Access Compliance Report Public Rights-of-Way (Curb Ramps)

Main Street: SNAPDRAGON_ST Cross Street: SKLAR_ST Location: SE

ADA ID: RPAT211101111408 Ramp Type: Type 4 - Parallel Initial Pass/Fail: Pass Overall Compliance: No Severity Score: 14

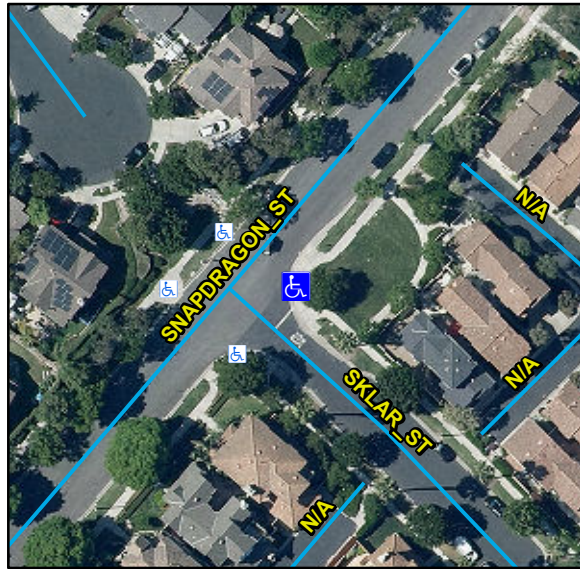
Compliance	Description	Data	Compliance	Description	Data
N/A	Ramp Length LT (in)	110	N/A	Ramp Length RT (in)	82
Yes	Ramp Width LT (in)	89	Yes	Ramp Width RT (in)	88
Yes	Ramp Run Slope LT (%)	6	Yes	Ramp Run Slope RT (%)	7
Yes	Ramp Cross Slope LT (%)	0.3	Yes	Ramp Cross Slope RT (%)	1.8
N/A	Landing Present	Yes	No	DWS Provided	No
N/A	Landing Length (in)	87	N/A	DWS Contrast	N/A
No	Landing Width (in)	47	N/A	DWS Length (in)	N/A
Yes	Landing Run Slope (%)	0.7	N/A	DWS Full Width	N/A
Yes	Landing Cross Slope (%)	0.2		DWS Offset Type	N/A
N/A	Landing Movement Obstructed?	No	N/A	DWS Offset Left (in)	N/A
	Landing Movement Type	Curb	N/A	DWS Offset Right (in)	N/A
N/A	Landing Shared	No			
N/A	Clear Space	Yes			
N/A	Clear Space To Crosswalk (in)	48			
N/A	Marked Crosswalk 1	No	N/A	Marked Crosswalk 2	No
	Crossing 1 Direction	N		Crossing 2 Direction	W
N/A	Marked Crosswalk 1 Width (in)	N/A		Marked Crosswalk 2 Width (in)	N/A
N/A	Ramp Inside Crosswalk 1	N/A	N/A	Ramp Inside Crosswalk 2	N/A

Crossing 1 Slope (%)	0.4		Crossing 2 Slope (%)	1.5
	Crossing 1 Cross Slope (%)	0.5		Crossing 2 Cross Slope (%)	0.6
Yes	Gutter Ponding	No	No	Curb Slope	18
Yes	Gutter Lip Height (in)	0		Road Run Slope (%)	1.6
Yes	Gutter Run Slope (%)	3.3		Road Cross Slope (%)	1.2
No	Gutter Cross Slope (%)	2.5	No	Perpendicular Joint Present	No
Yes	Overall Surface Condition	Acceptable			
	Cross Gutter Present?	No		Spandrel Present?	No
	Replace Cross Gutter?	N/A		Replace Spandrel?	N/A

Remove & Replace Curb Ramp With Two New Directional Ramps or Equivalent. Remove & Replace Gutter.

R304.2.2, R204.3, R304.2.1, R305, R304.5.3, STD 1115
